COVER SHEET FOR PRELIMINARY/FINAL SUBDIVISION AND LAND DEVELOPMENT PLAN SM&B ENTERPRISE LLC FAIRVIEW ROAD MOUNT JOY TOWNSHIP LANCASTER COUNTY, PENNSYLVANIA DRAWING #: CG-4082 SHEET #: 1 OF 31		PROJECT NO.: 5183-20 DATE: JUNE 10, 2026 DRAWN BY: BRC CHECKED BY: BRC SCALE: 1"=100'
---	--	--

Re: Final Subdivision and Land Development Plan for SM&B Enterprises, LLC
Our File No. 10221-1

Re: SM&B Enterprises LLC
Final Subdivision and Land Development Plan
Township Permit No. 26-04-FSDP
LCEC Project No: 25-241

DRAWING #: CG-4082 SHEET #: 8 OF 31	
L.C.P.C. #: 11-58-1

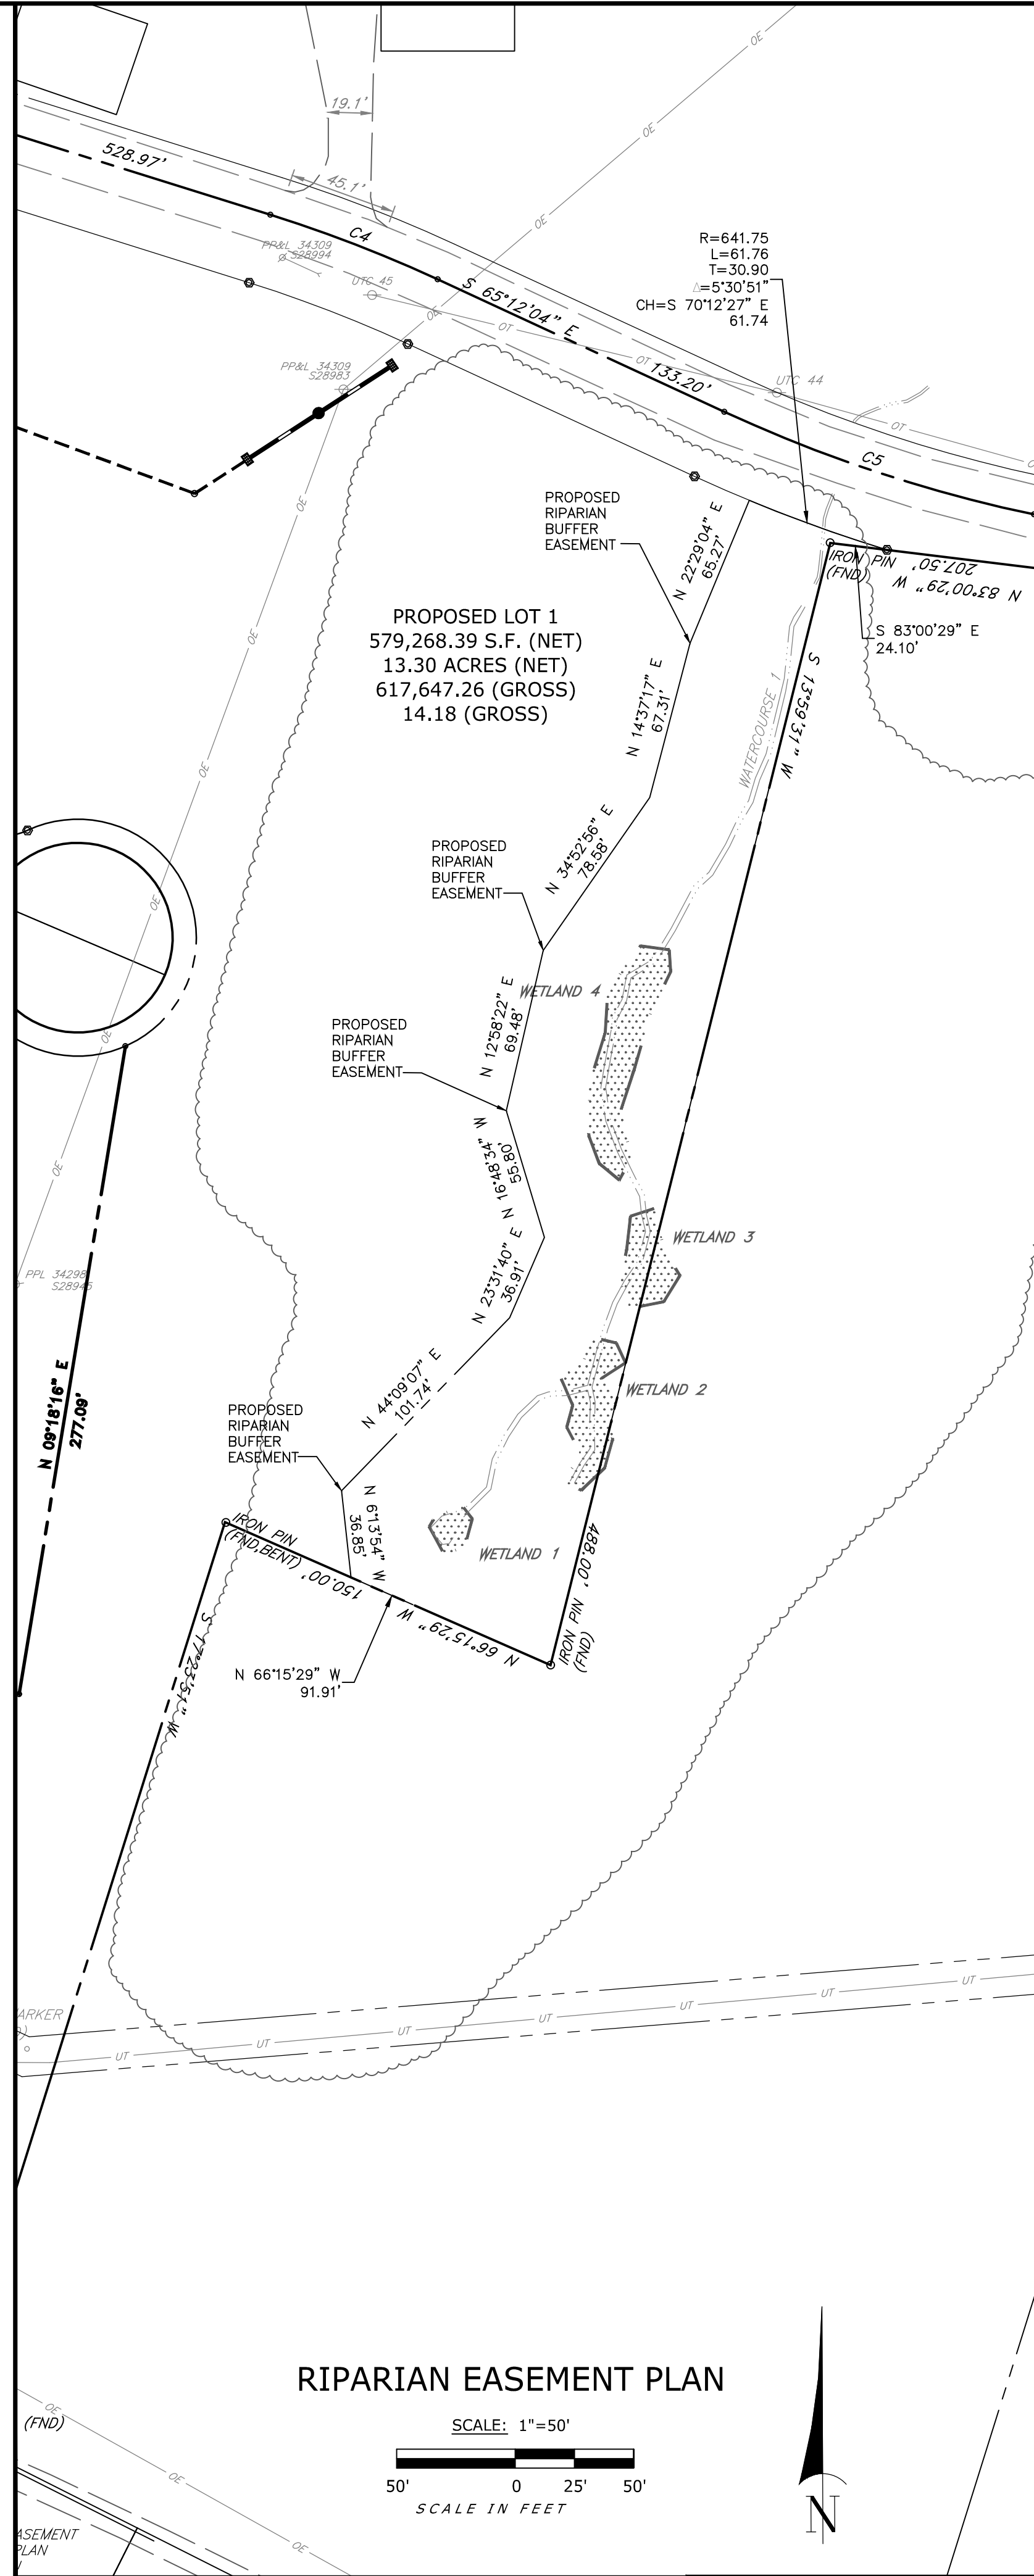
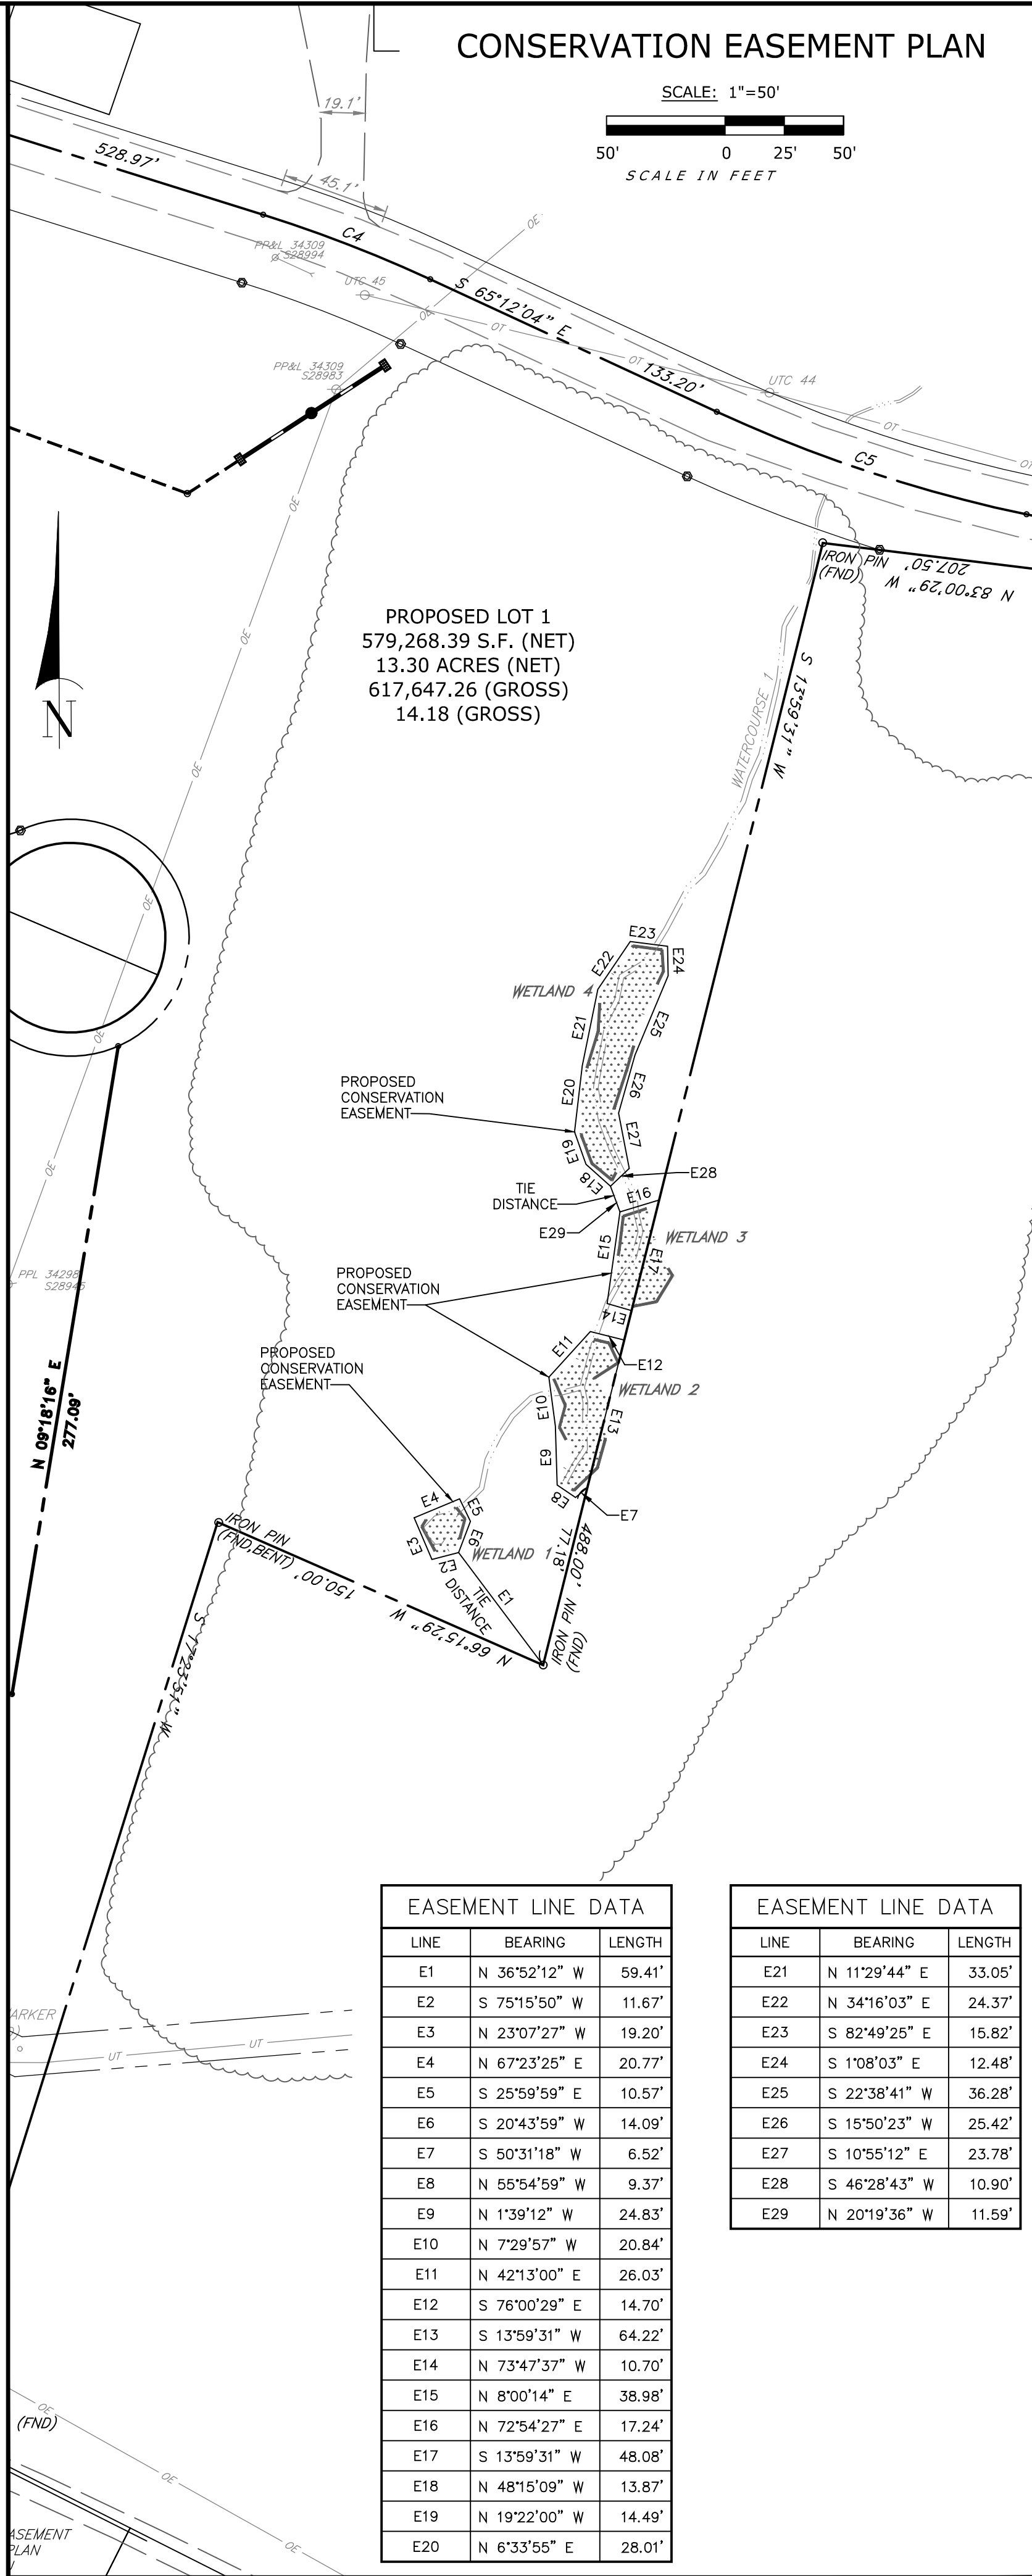
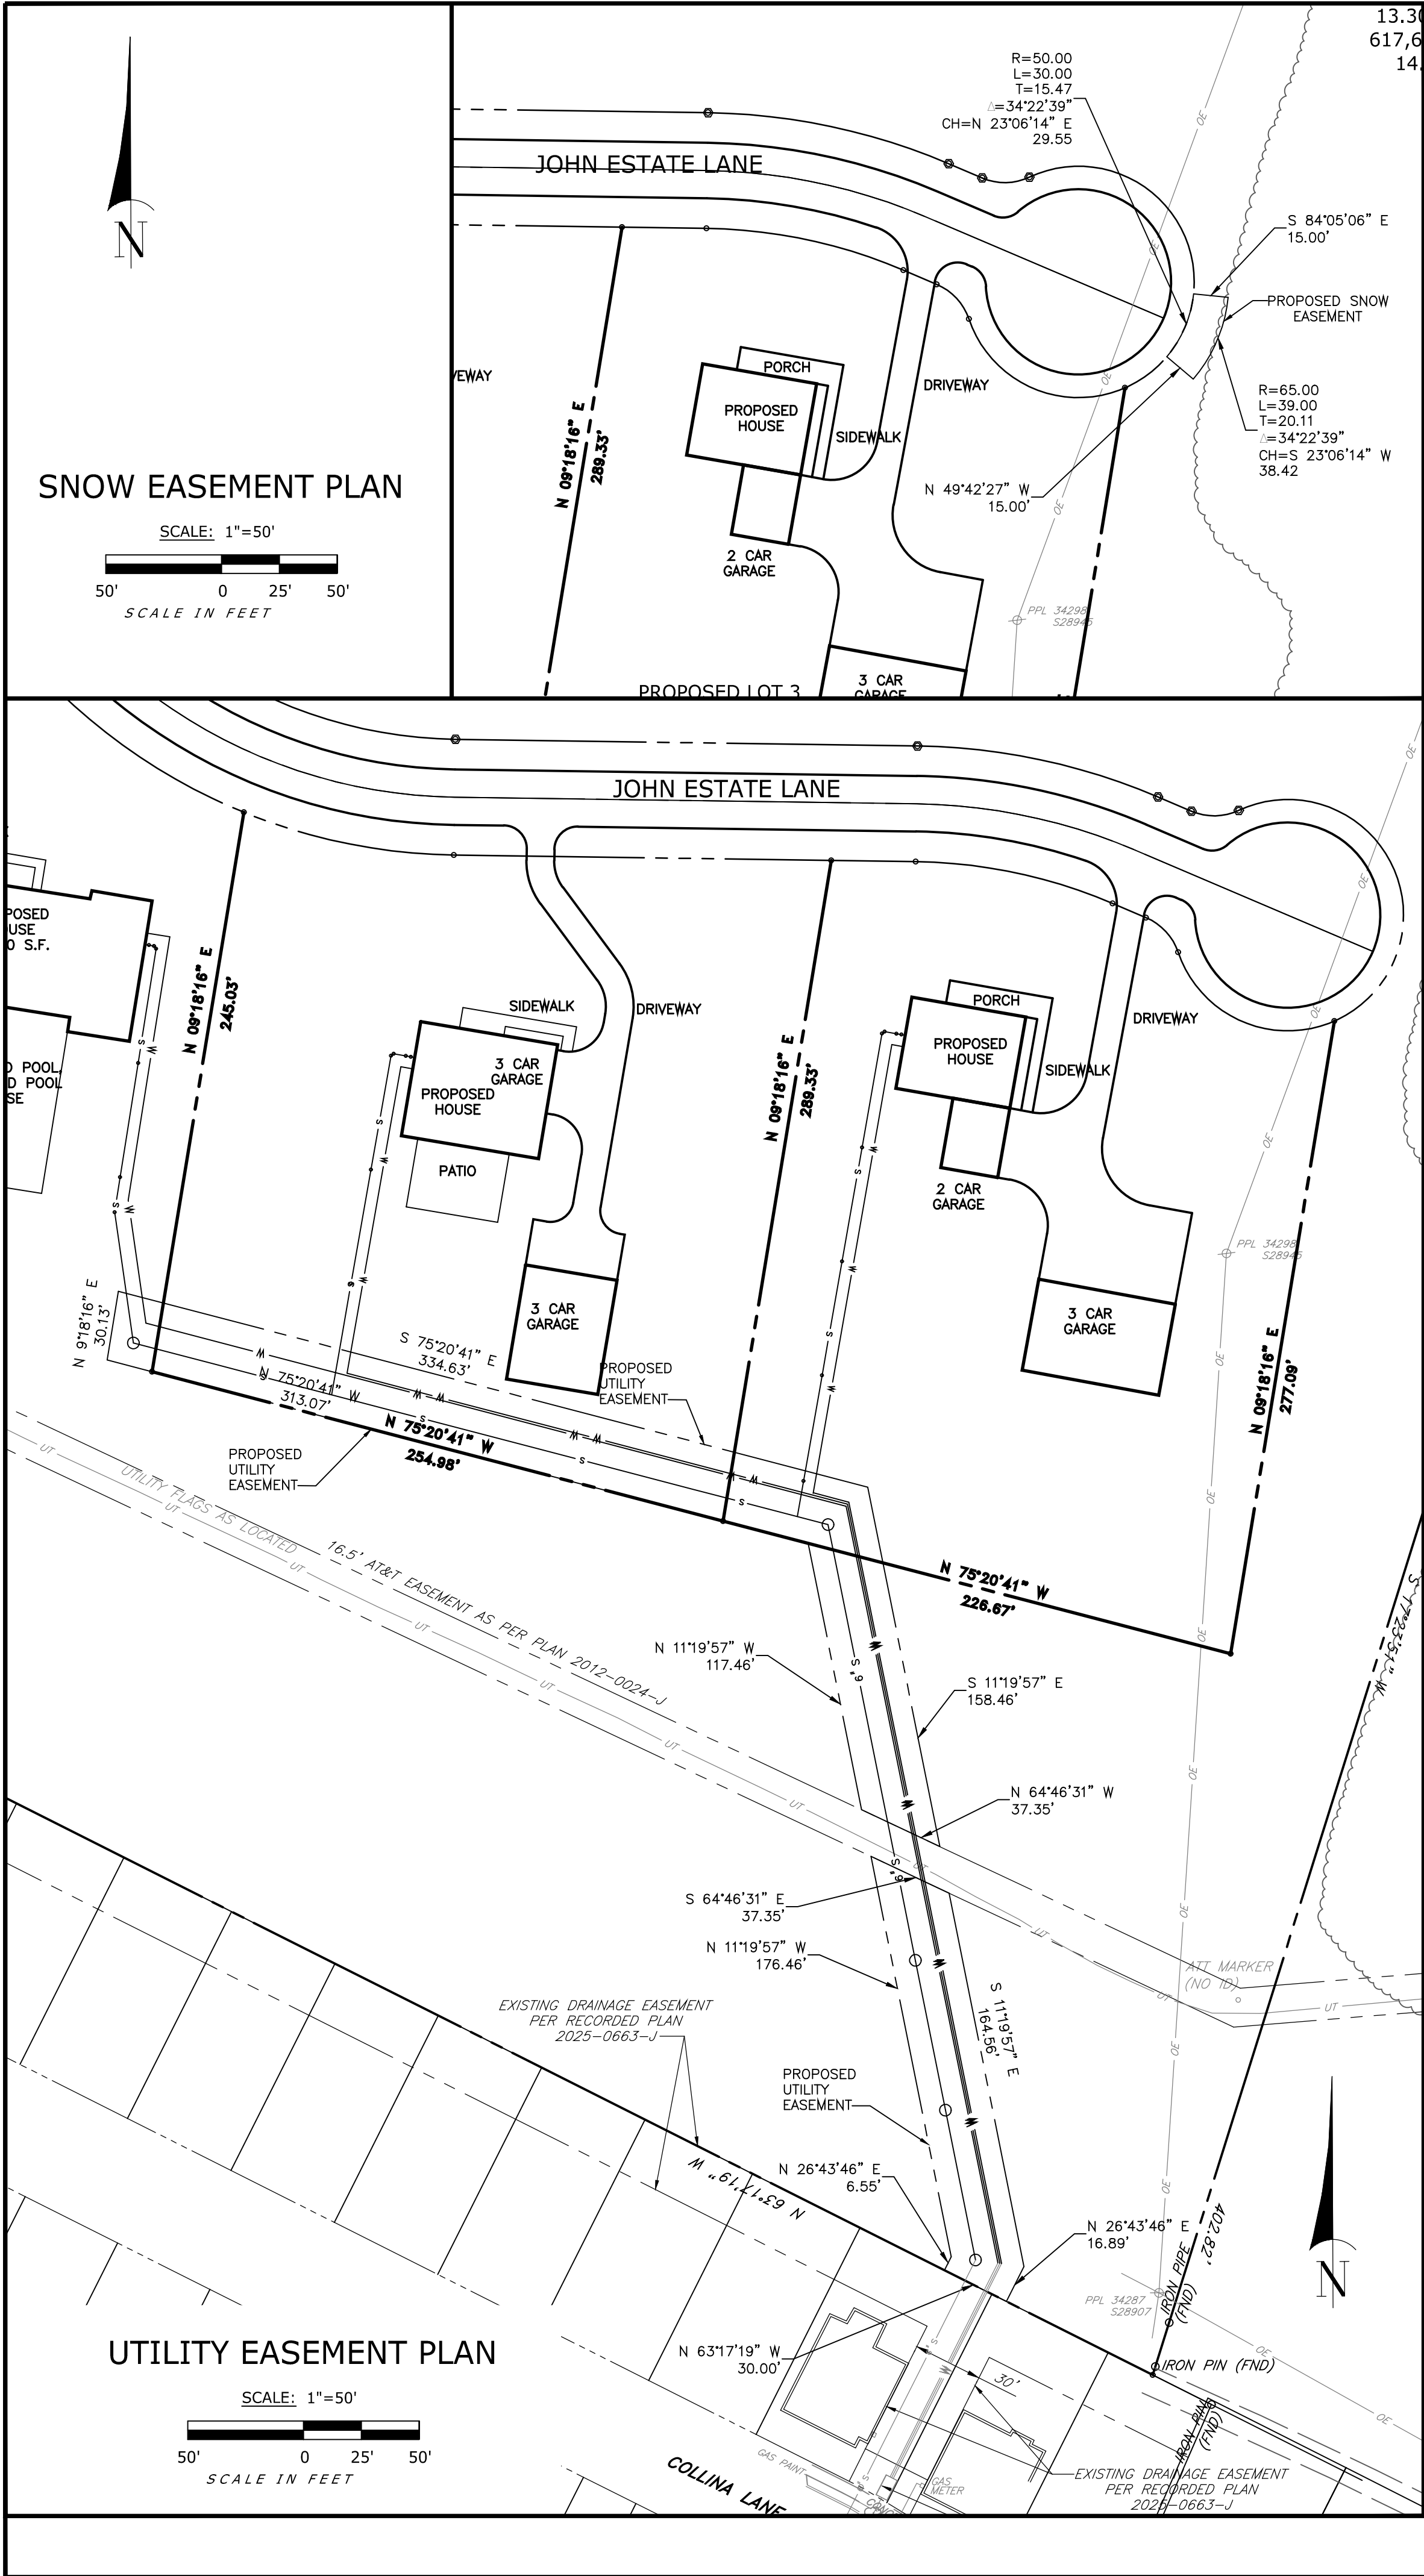
There are areas of wetlands on the eastern boundary, as well as a water course. Sheet 8 proposes the creation of a riparian buffer easement and a conservation easement. There should be an Agreement Providing for Grant of Conservation Easement which would include both the proposed conservation easement over the wetlands delineated on Sheet 8 and the riparian buffer easement which includes all of the wetlands.
